**TOWN OF PORTOLA VALLEY
ARCHITECTURAL AND SITE CONTROL COMMISSION (ASCC)
Monday, March 24, 2014
7:30 PM – Regular ASCC Meeting
Historic Schoolhouse
765 Portola Road, Portola Valley, CA 94028**

TO: ASCC
FROM: Karen Kristiansson, Deputy Town Planner
Carol Borck, Assistant Planner
DATE: March 21, 2014
RE: Agenda for March 24, 2014 ASCC Meeting

4a. PRELIMINARY ARCHITECTURAL REVIEW FOR NEW RESIDENCE, DETACHED GUEST HOUSE, AND SITE DEVELOPMENT PERMIT X9H-672, 18 REDBERRY RIDGE, DOUGLASS

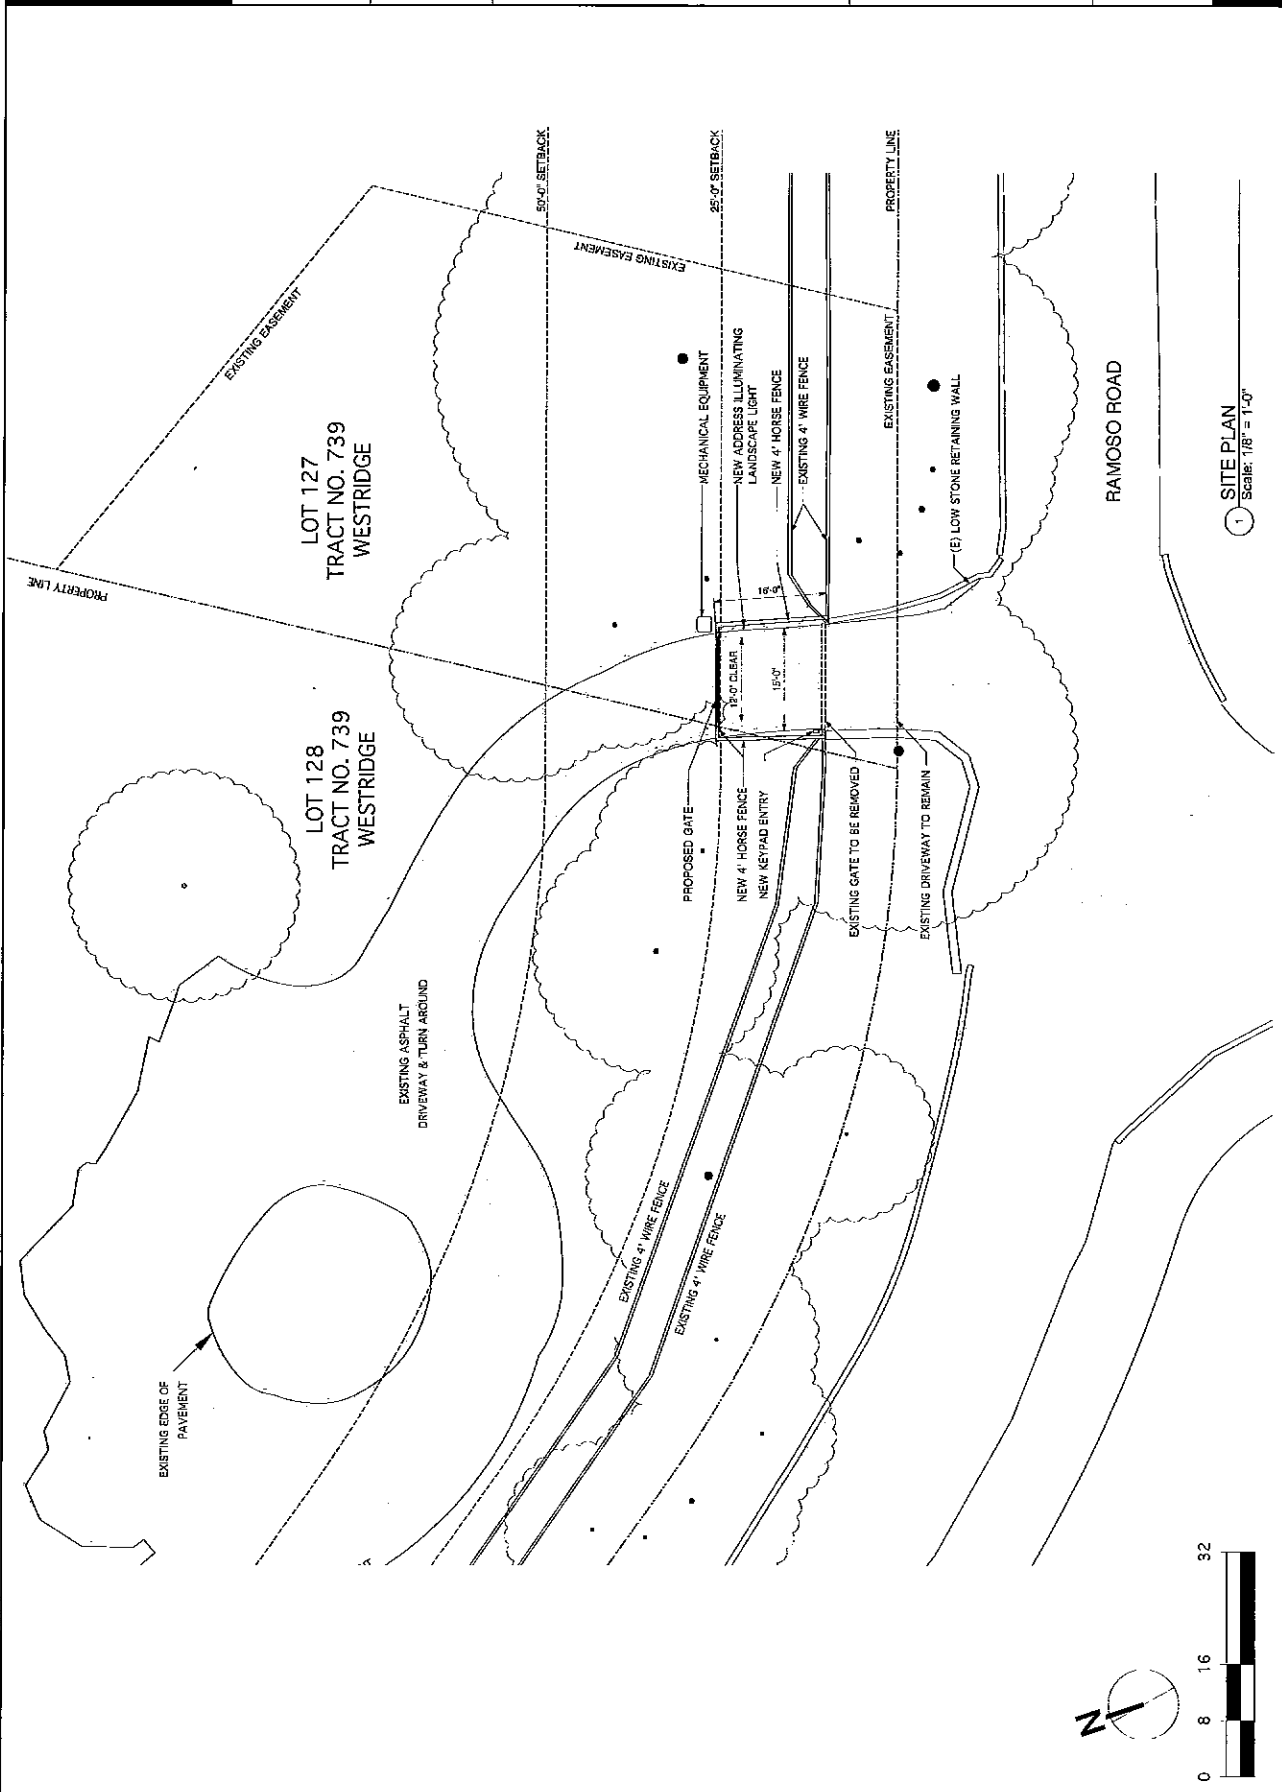
New wood and wire fencing is proposed to extend from the new gate to the existing post and wire fencing on either side of the driveway as shown on Sheet A0.02. The new fencing is designed to conform to the Town's horse fencing regulations as is required within this zoning district. We have discussed the proposed black painted wire with the architect and clarified that the wire will be standard 6" wire mesh. Additionally, the wire mesh will be left natural rather than painted black.

Call box location and lighting. The location of the proposed key pad is shown on Sheet A0.02 and specifications shown on Sheet A0.03. There is no lighting associated with the call box; however, the site plan indicates a "new address illuminating landscape light." The fire department does not require that addresses be illuminated, and typically, this type of lighting is not supported by Town guidelines.

1. The site plan shall be revised to eliminate the proposed address illumination landscape light.
2. The proposed wire on the new fencing shall be 6" wire mesh and left in a natural condition rather than painted black.

SHEET TITLE
**DEMOLITION,
 FLOOR AND ROOF
 PLANS**

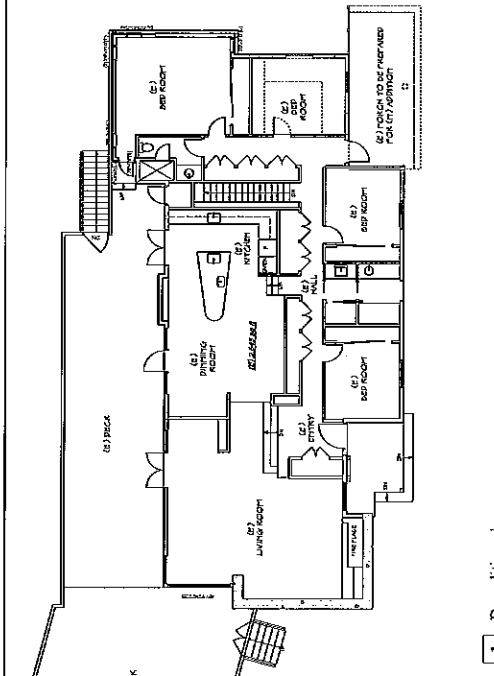
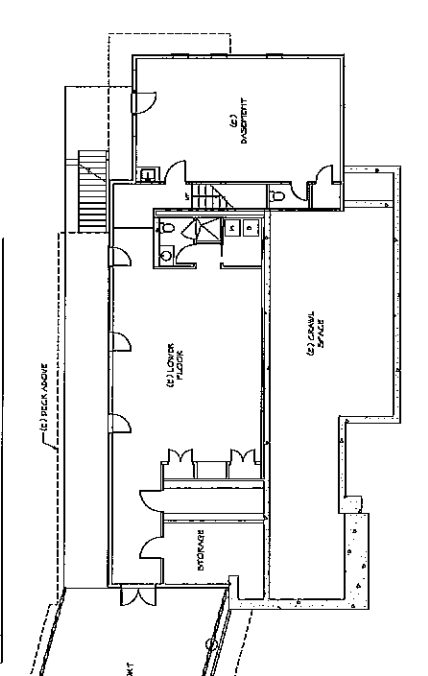
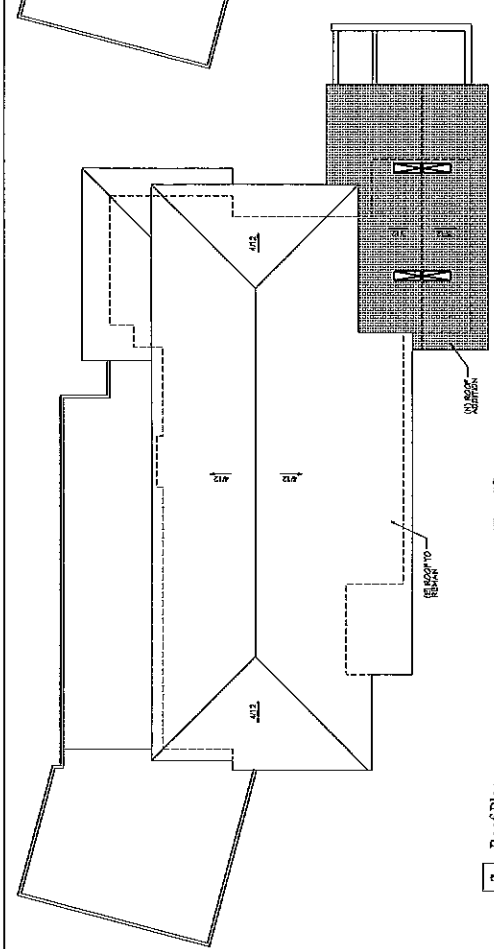
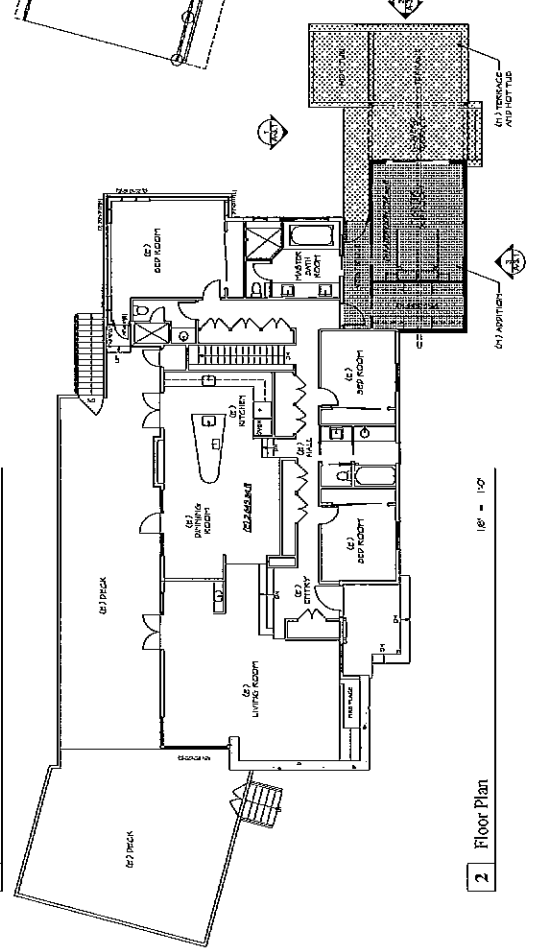
The proposed addition would create a new master bedroom with walk-in closet at the southeastern, rear corner of the house. Proposed immediately east of the new master bedroom is a partially covered terrace and hot tub. An existing bedroom would be remodeled into the new master bathroom. This area of the property is relatively level, and minimal grading would be required for the project. The roof of the addition would have a 3:12 slope and include four small skylights at the ridge as shown on Sheet A-2.1. As the site is well-screened by existing trees and vegetation, it appears that the skylights and the addition would have little potential for off-site impacts. Further, given the scope of existing vegetation along the Portola Road side of the property, and site slope conditions, the house addition and new terrace would be virtually invisible from Portola Road corridor views. Thus, no impacts on the conditions along the Road corridor are anticipated.

Portions of the proposed additions utilize the zoning ordinance averaging provision. A corner of the master bedroom closet would encroach approximately one and a half feet into the 20-foot rear yard setback, while the overall average setback of 20 feet is maintained as is the minimum clear yard area of 80% (i.e., in this case at least 16 feet). The site plan also shows that the proposed terrace and four-foot high wall would encroach into the 10-foot side yard setback. As the terrace is considered a separate structure from the home, it may not encroach into the setback as proposed and will need to be shifted in a manner so that it is completely clear of the setback or so it too can meet the setback averaging provisions. For example, since the hot tub is a portable unit, the portion of the terrace where the tub would be located could remain as proposed and the terrace area immediately to the south could be reduced in size so that the average required east side setback of 10 feet is maintained. This matter has been discussed with the architect and adjustments will be made with the building permit submittal.

1. A detailed construction staging and tree protection plan shall be provided prior to building permit issuance. Once approved, the plan shall be implemented also to the satisfaction of planning staff.
2. The site plan shall be revised so that the proposed hot tub, terrace, and wall adhere to the 10-foot side yard setback zoning ordinance provisions.
3. The colors and materials for the proposed terrace and wall shall be specified and approved prior to building permit issuance.
4. All existing flood-type lighting shall be removed prior to building permit final inspections.
5. Lighting under the skylights in the new master bedroom shall be specified and approved with the building permit submittal.
